2. AMENDMENT/MODIFICATION NO. 0003	3. EFFECTIVE DATE 30 MARCH 2004	4. REQUISITION/PURCHASE REQ. NO.	5. PROJECT NO. (If applicable)
6. ISSUED BY CODE	W912EP	7. ADMINISTERED BY (If other than Item 6) CODE	W912EP

LAKE OKEECHOBEE WATER RETENTION, PHOSPHORUS REMOVAL PROJECT, NUBBIN SLOUGH - NEW PALM STORM WATER TREATMENT AREAS, OKEECHOBEE COUNTY, FLORIDA

END OF AMENDMENT NO. 3

DRAWING NO.
C152

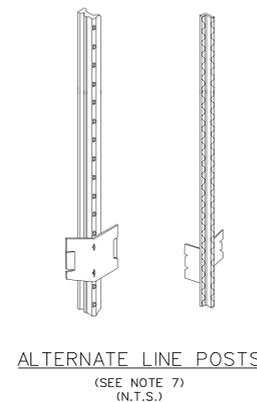
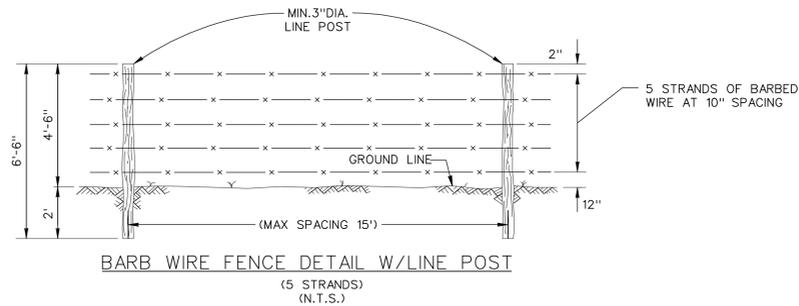
- a. Delete drawing C 152 Det1 in its entirety and replace with the attached revised drawing C 152 Det1:
- b. Delete drawing C 155 Det1 in its entirety and replace with the attached revised drawing C 155 Det1:
- c. Delete drawing M 101 PSPLM in its entirety and replace with the attached revised drawing M 101 PSPLM:

No.	Symbol	Zone	Description
1	△	C5, C4	REVISED TO ACCOMPANY AMENDMENT 0003

DRAWING NO.
C155

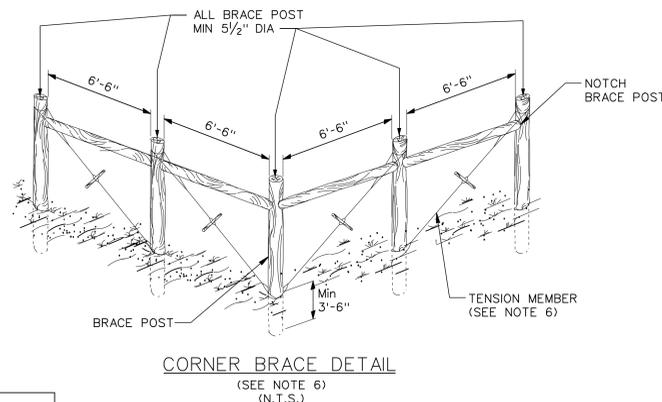
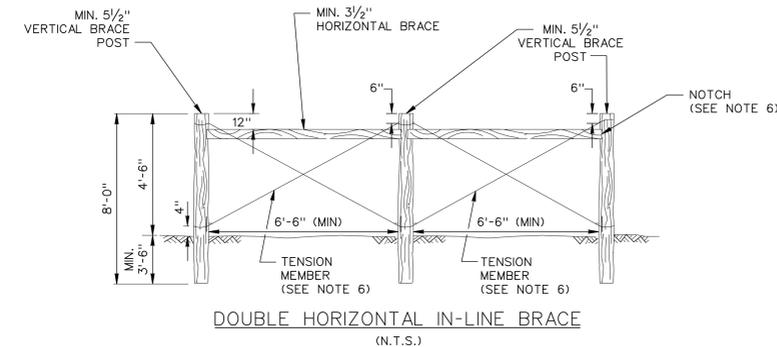
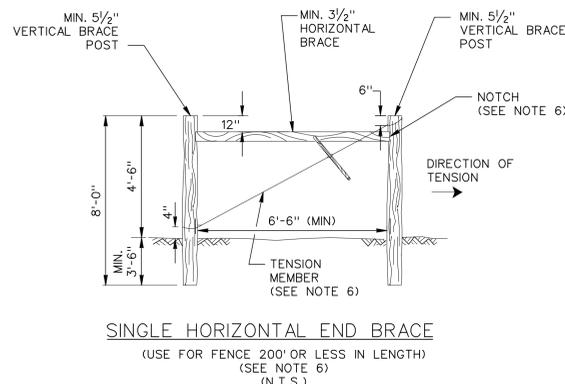
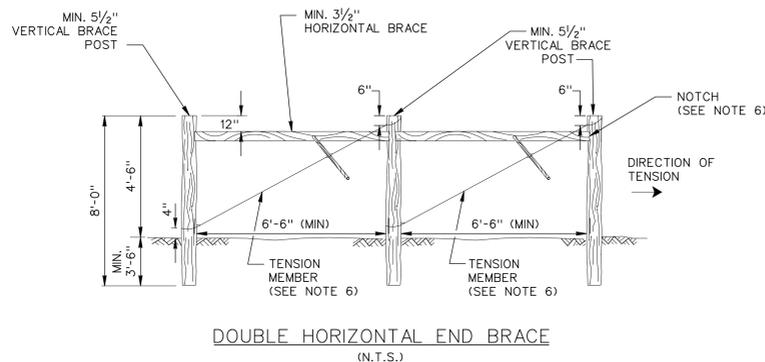
1	Symbol	Zone	D.3	REVISED TO ACCOMPANY AMENDMENT 0003
---	--------	------	-----	-------------------------------------
